ADDENDUM No. 2

Reference: Murdock Guest House Adaptive Re-Use
Utah Valley University – Orem, Utah
DFCM Project No. 08307790

PROJECT NAME: UTAH VALLEY UNIVERSITY MURDOCK GUEST HOUSE ADAPTIVE RE-USE ADDENDUM NO.: 1
DFCM PROJECT # 08307790
DATE: JANUARY 21 2009

FROM: ATLAS ARCHITECTS
TO: ALL BIDDERS

RAMP DETAIL - TYP. (A2.1)
SCALE: 3/4"=1'-0"

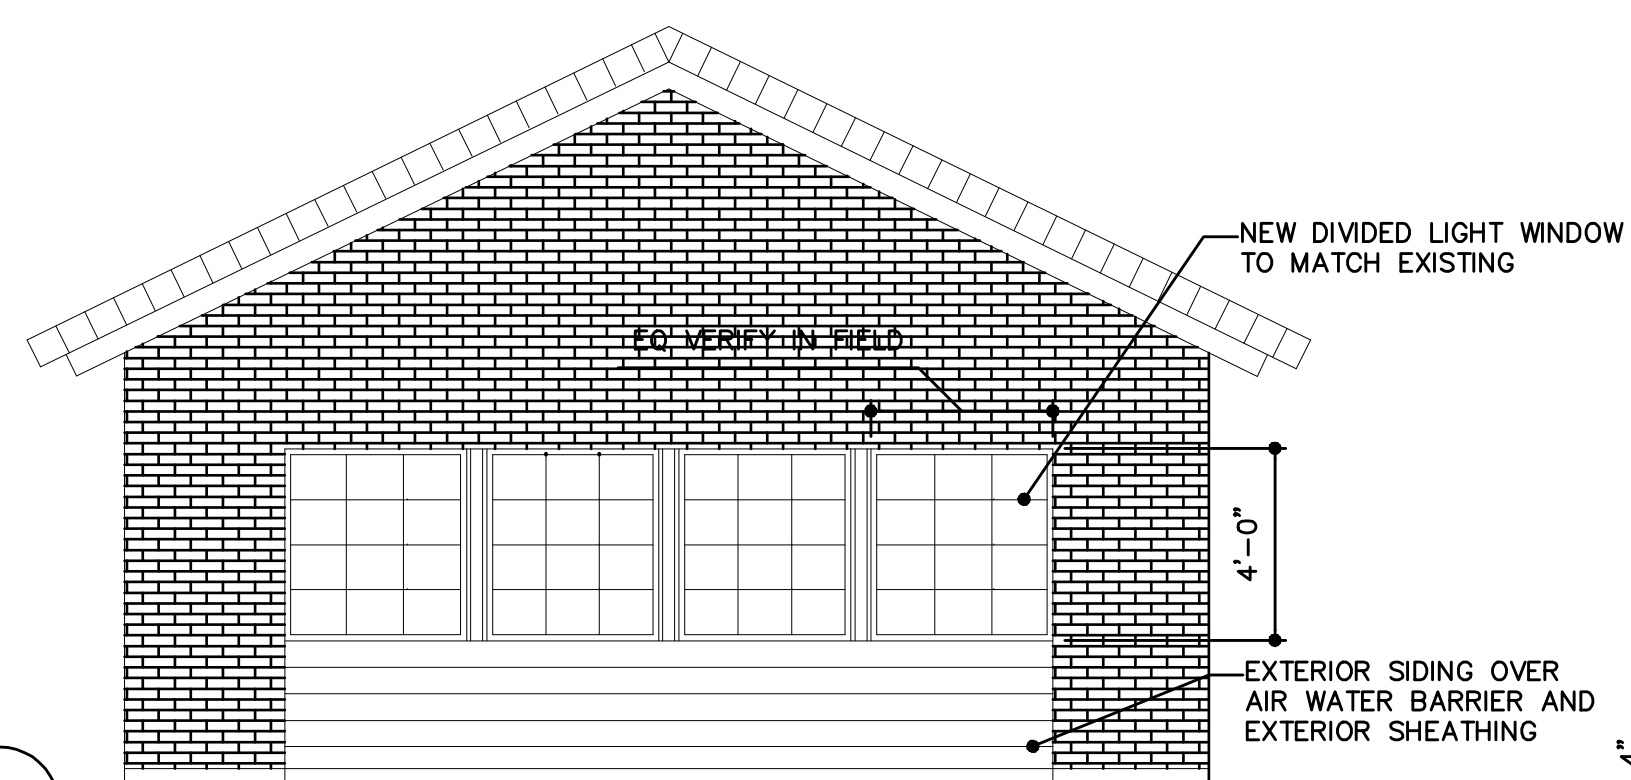
1. THIS IS A "TAX EXEMPT PROJECT"
2. 03/A2.1 IS TO BE CONSIDERED TYPICAL WALL DETAIL FOR ENTIRE PERIMETER OF RAMP AND INTERMEDIATE WALL BETWEEN RUNS - PROVIDE EXPANSION JOINT FILLER BETWEEN RAMP AND EXISTING BUILDING

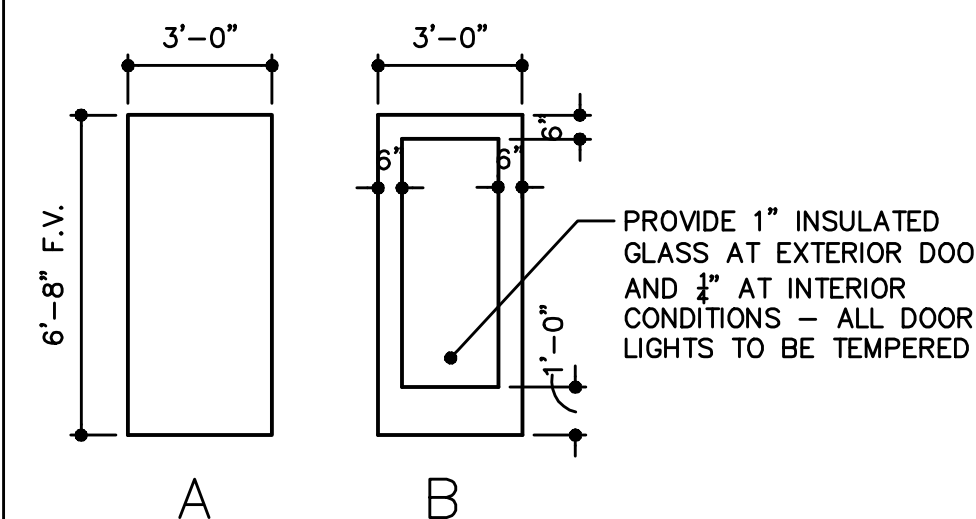
AUTO DOOR OPENERS HAVE BEEN ADDED TO THE MAIN ENTRANCE AS WELL AS BOTH TOILET ROOMS

For opening 11 delete one closer and add one 6860 Norton Auto Operator with two 685 Norton Actuators.
For openings 8 and 20 delete the privacy latch and add one 485 Sargent Deadbolt and one 5700 Norton Auto Operator with two 685 Norton Actuators.

SHEET #
ME1.1

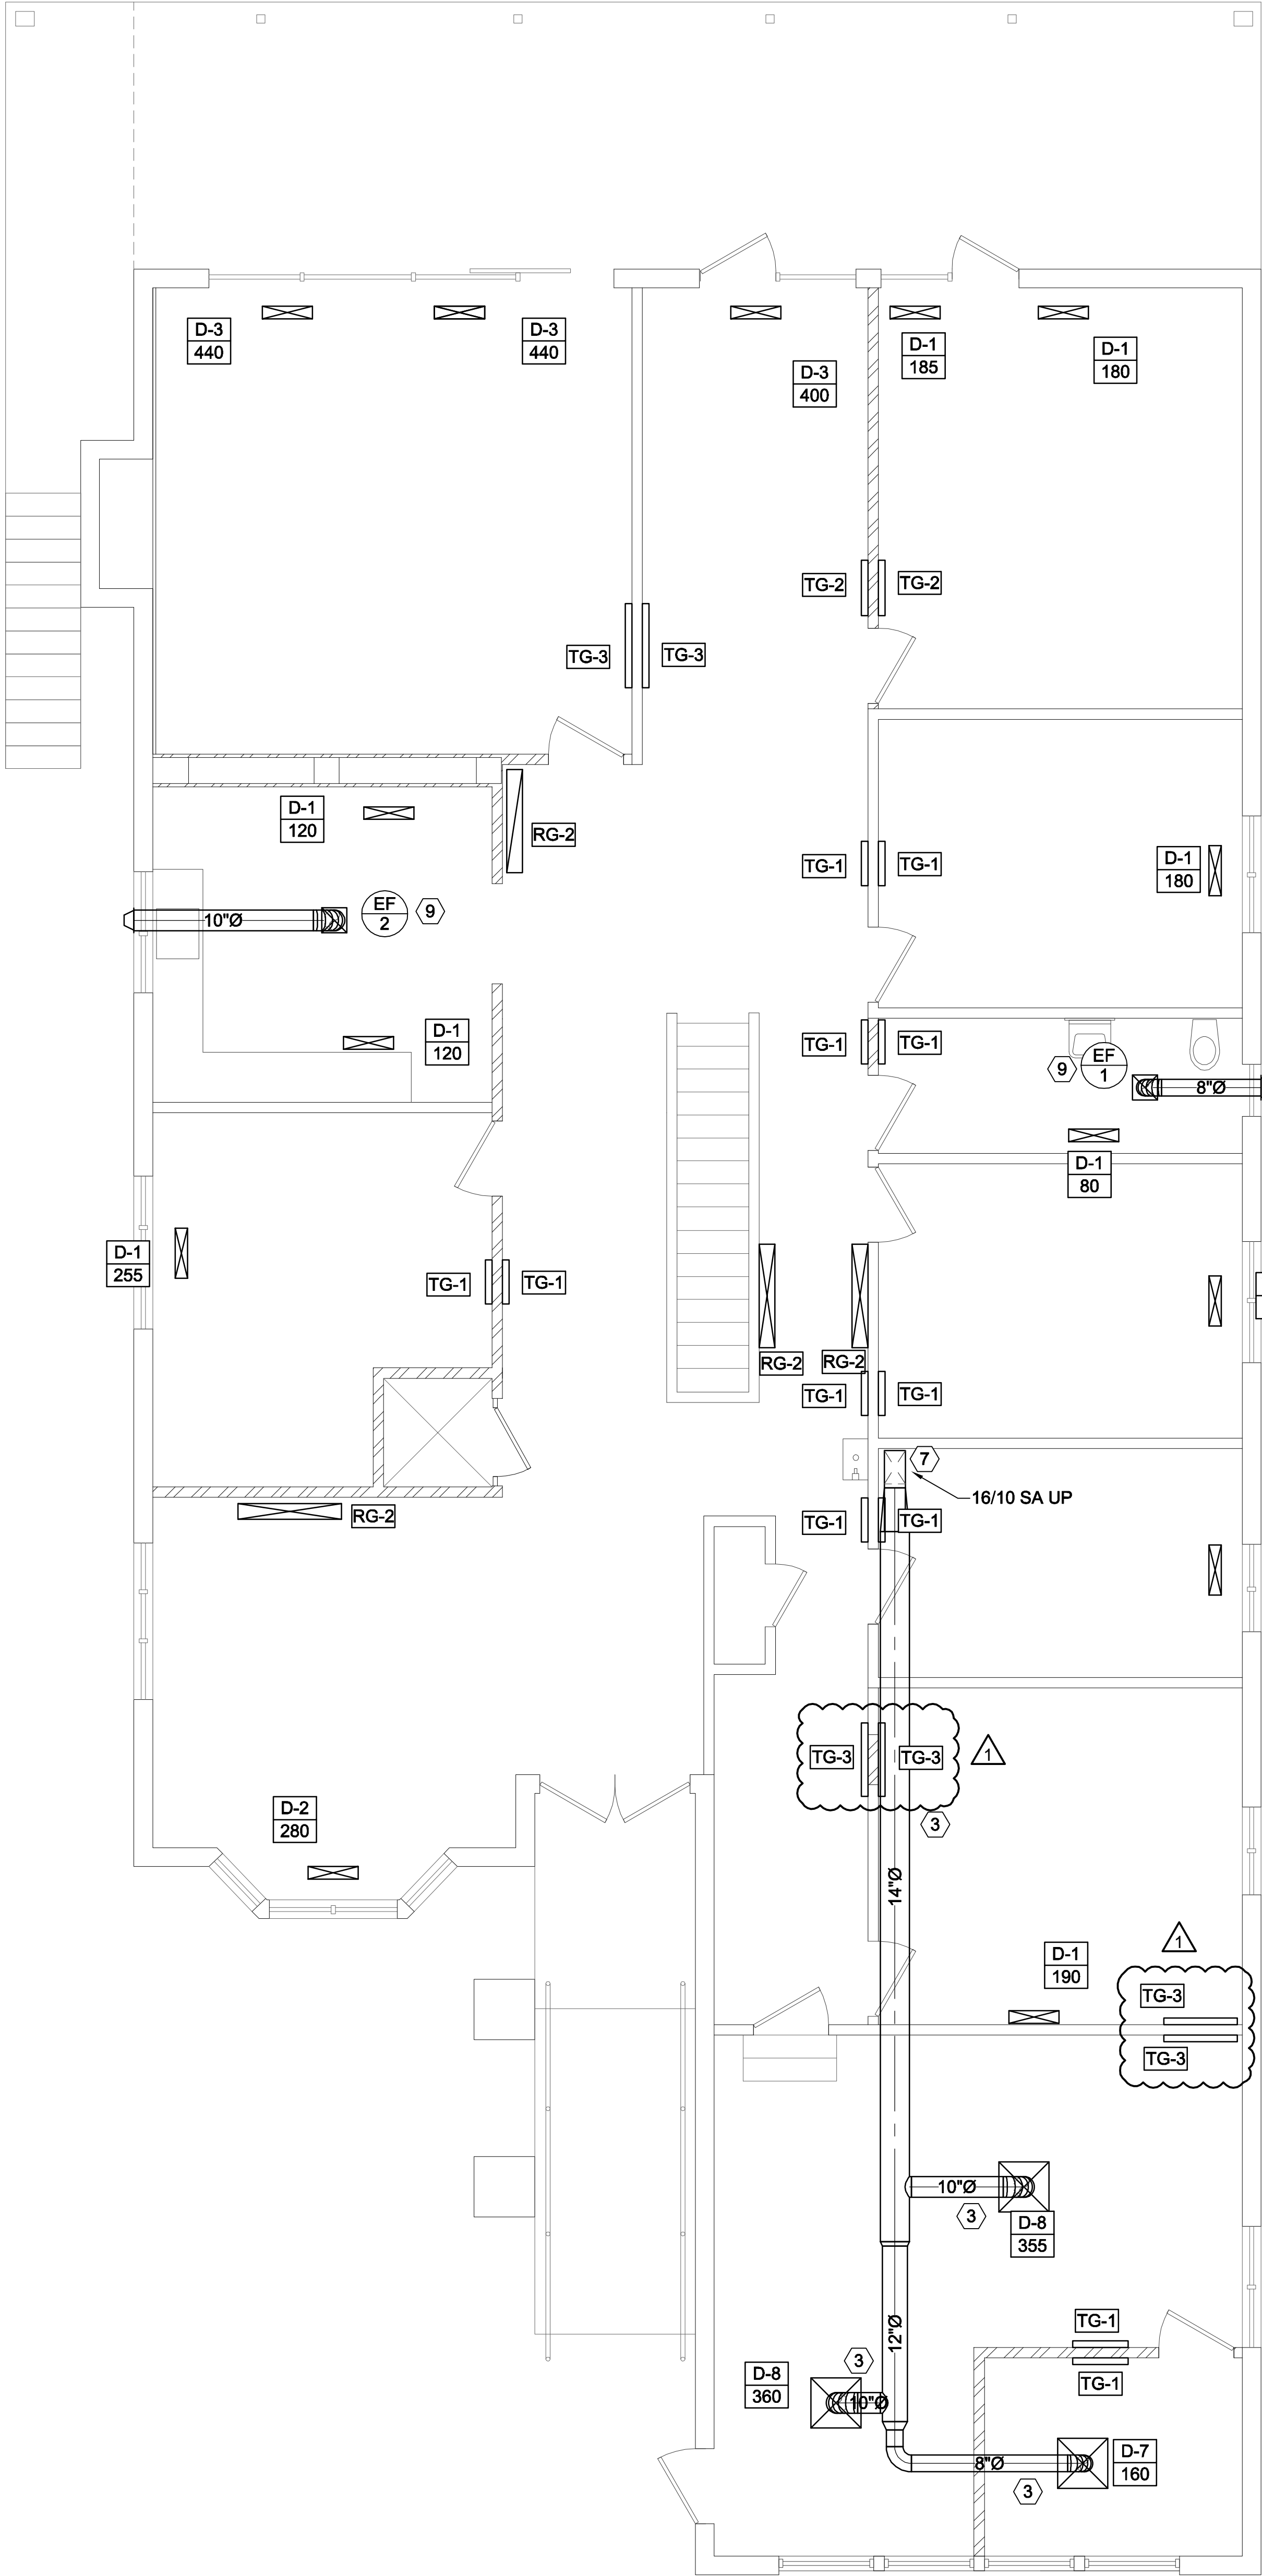
Item III-1. Modified transfer air to accommodate floor plan change. See sheet ME101.
